Objection submission COM/2019/81 -

State Development Assessment Provisions (SDAP) - Native Vegetation Clearing requirements

Attachment B1 - Plan 362-010 (annotated)

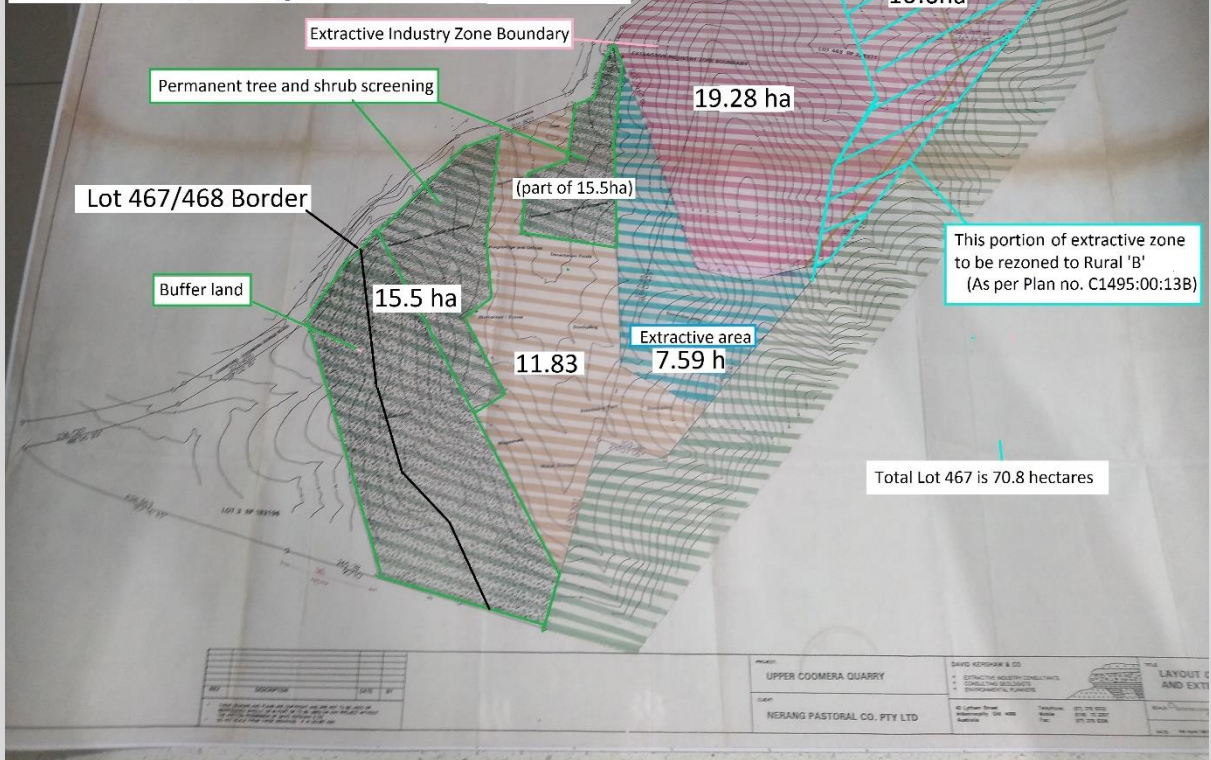
I do not believe the complete rape and pillage of Lot 467, from the limited extractive footprint in the Current approval of 23.77 ha approx (as shown in attachment B1), to the ABSOLUTE MAXIMUM FOOTPRINT for the Lot (as shown in attachment B4), that is ignoring City Plans to not go within 40 m of Lot boundary (City Plan 9.3.8 Extractive Industry Code, Acceptable Outcome AO3.1 - Attachment E2), and ignoring City Plans to not go within 40m of ridgelines (City Plan 9.3.8 Extractive Industry Code, Acceptable Outcome AO4 - Attachment E2) and is further ignoring all the protected development areas under their Current approval, that were obviously agreed to limit urban and quarry encroachment and limit views into the quarry (as per City Plan 9.3.8 Extractive Industry Code, Acceptable Outcome AO3.2 requirements - Attachment E2) i.e. 'Buffer Land' and 'Permanent Trees and shrub screening' areas (attachment B1.) and prohibited development area Rural 'B' (attachment B2, close up in B3) is as per Performance Outcome PO5 requirements. The existing vegetation in this lot is being decimated in every single direction radiating out from the quarry with no apparent regard for the local environment and/or the local ecosystem.

Total extractive footprint is 23.77 ha $(19.28 - 2.1) + (7.59 - 1)$ NOT the claimed 56.02 ha

Attachment B5 - City Plan - Showing Environmentally significant areas and prohibited development areas

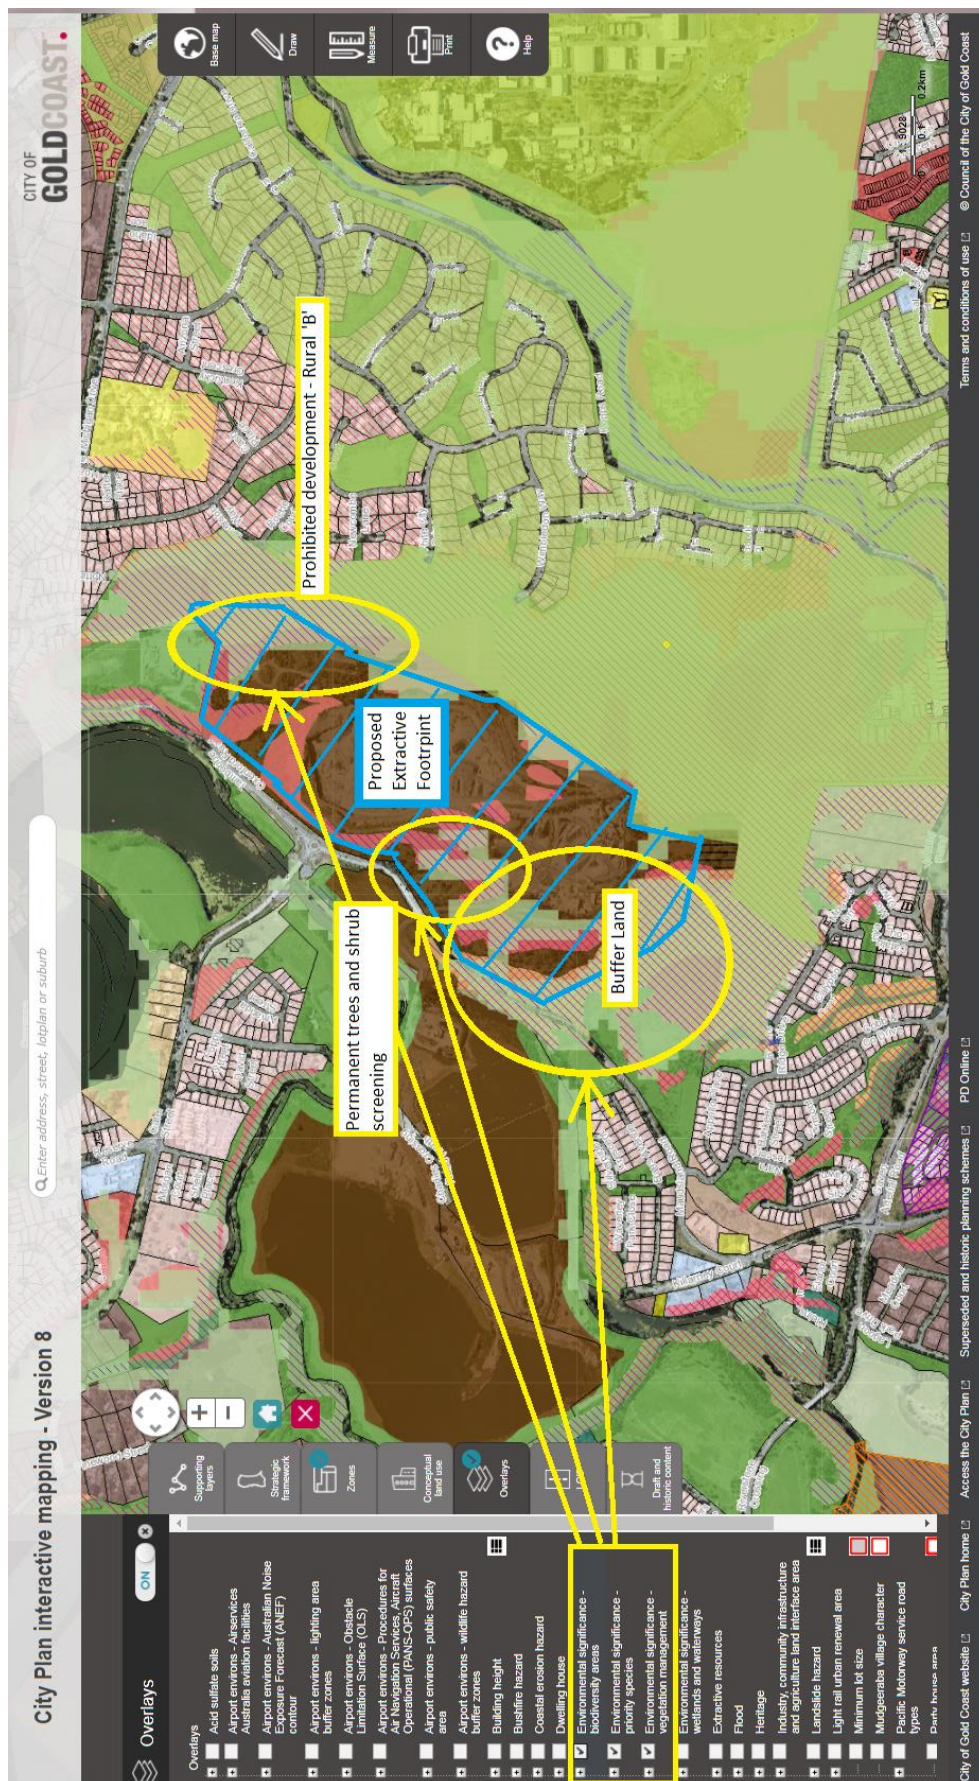
The proposed extractive footprint (as shown in Attachment B4) engulfs all these prohibited development areas that were agreed as part of the Current approval for the life of the quarry (as shown in the City Plan, reproduced in Attachment B5).

Attachment C1 - Environmental significant Wetlands and Waterways

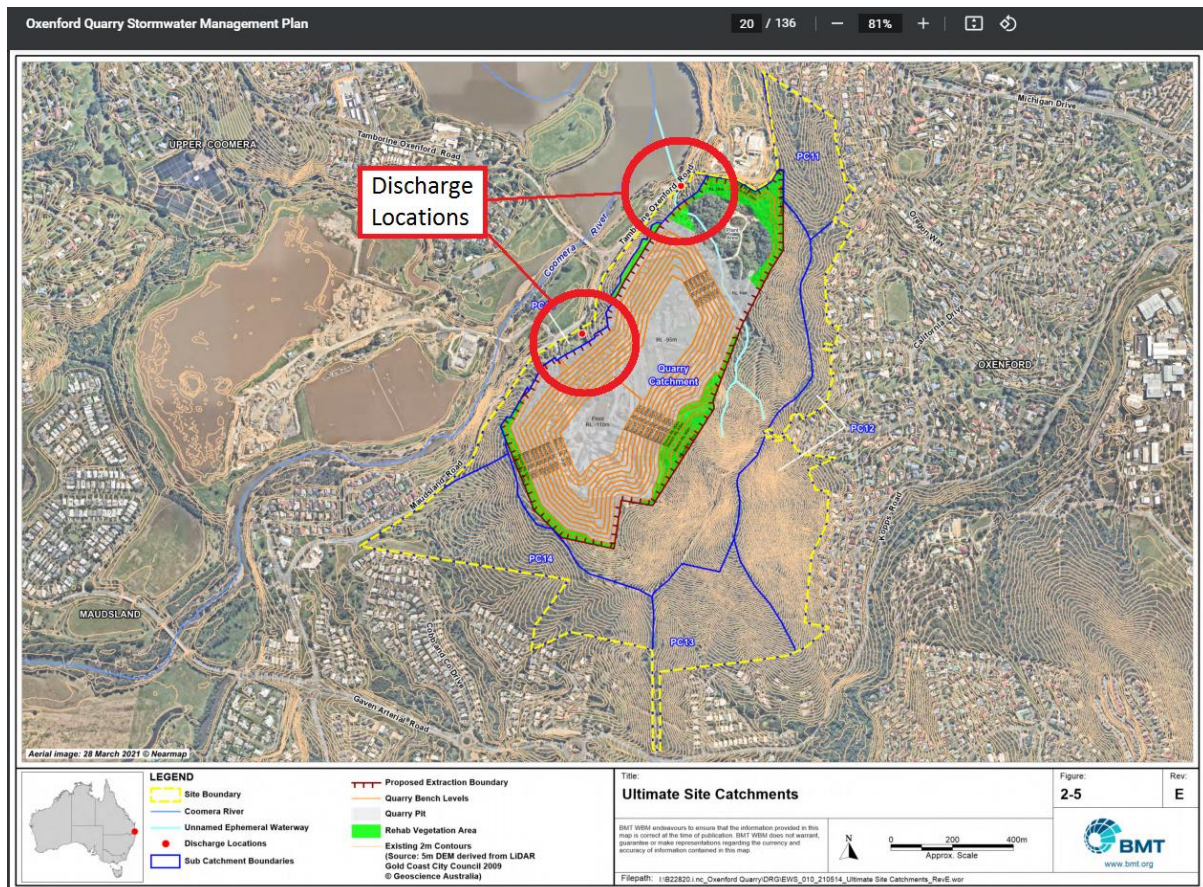
I believe Acceptable Outcome AO3.1 *“Clearing does not occur in. or within 100 metres of any natural wetland”* is not met, as shown on the City Plan - Environmental significance Wetlands and Waterways overlay (reproduced in Attachment C1).

Attachment D1 - Quarry discharge locations into Coomera River

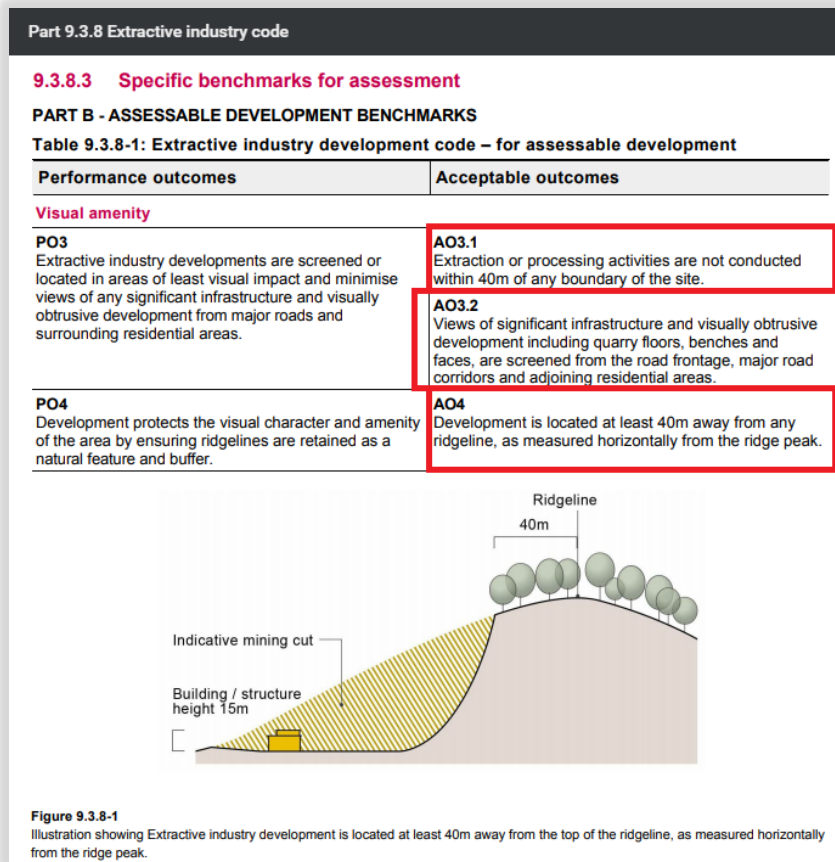
Quarry discharge locations into the freshwater part of the Coomera River are shown in Attachment D1.

I also note an Acceptable Outcome requirement AO6.1 is *"Clearing does not occur in or within 200 meters of a discharge area or recharge area"* (Attachment A4). However it is clear to see that the discharge locations are adjacent to the extractive footprint / clearing and is definitely far less than the required 200 meters.
